TECHNICAL INFORMATION

72892
June, 2005

- Subject** ▶ Change of Ball Bearings 6902DDW
- For Models** ▶ BO6030
- Country** ▶ All countries
- Description** ▶ Two Ball bearings 6902DDW have been changed as illustrated below.

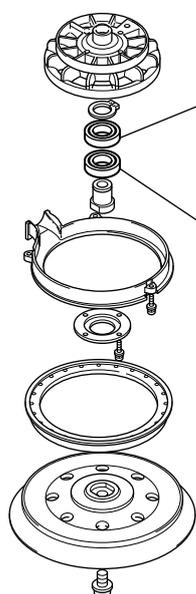
▶ Current	▶ New
CAT. No. Part number indication on seal color of seal	Ball Bearing 6902DDW (211239-2) 6902LH Blue	Ball Bearing 6902LLB (211234-2) 6902LB Black

▶ Current	▶ New
CAT. No. Part number indication on seal color of seal	Ball Bearing 6902DDW (211239-2) 6902LH Blue	Ball Bearing 6902LLU (211244-9) 6902LU Red

Item No.	Current part		Q'ty	I/C	New part		Q'ty	Note
041	Ball Bearing 6902DDW 211239-2		1	No	Ball Bearing 6902LLB 211234-2		1	
042	Ball Bearing 6902DDW 211239-2		1	No	Ball Bearing 6902LLU 211244-9		1

Put Ball bearing 6902LLB and Ball bearing 6902LLU in place and correct order as illustrated above.
Do not use the other parts instead of Makita genuine parts.
